UNITED STATES
NUCLEAR REGULATORY COMMISSION
WASHINGTON, D. C. 20555

November 23, 1976

RE: MONTICELLO NUCLEAR GENERATING PLANT
PRAIRIE ISLAND NUCLEAR GENERATING PLANT UNIT NOS. 1 AND 2

Enclosure:
Burnup-Dependent Correction
for Fission Gas Release
Models

FIGURE 1

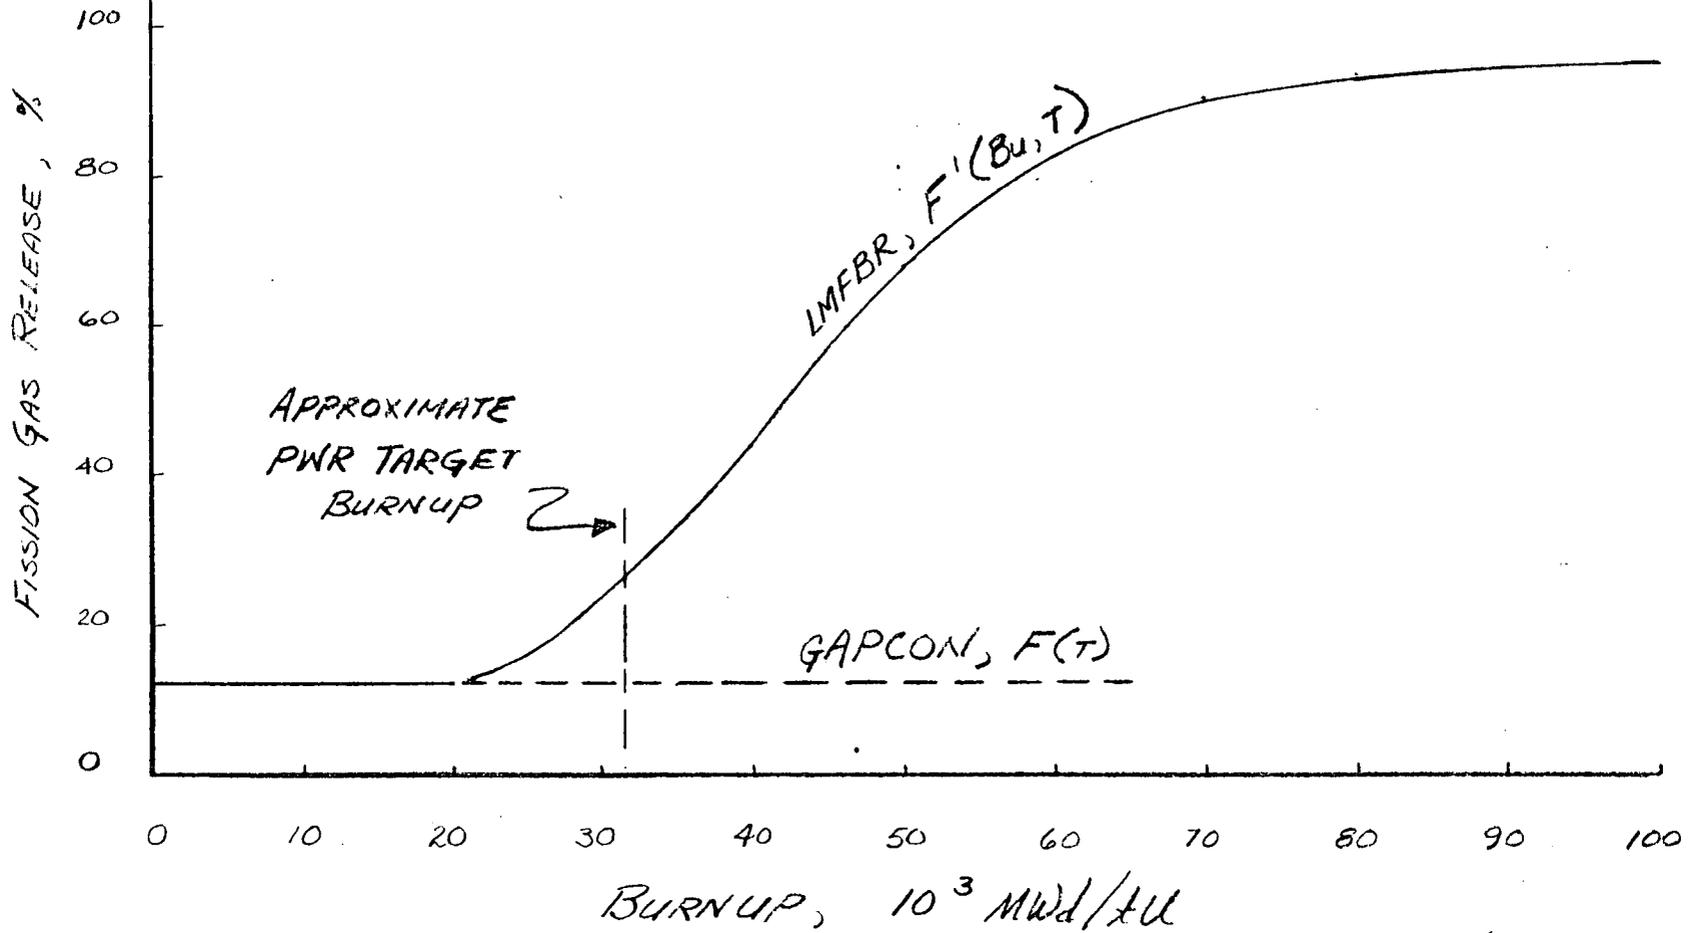
Figure 1 shows schematically how this correction would be applied to the GAPCON gas release model, which is independent of burnup. In the event an existing model contains a burnup dependence, $F(T)$ would be the predicted release fraction under the temperature conditions of interest, but with the burnup variable set equal to 20,000 MWd/tU.

$$F^*(Bu, T) = F(T) + [1 - F(T)] \frac{(1 - \exp[-0.436 \times 10^{-4}(Bu - 20000)])}{(1 + [0.665/F(T)] \exp[-1.107 \times 10^{-4}(Bu - 20000)])} \quad (1)$$
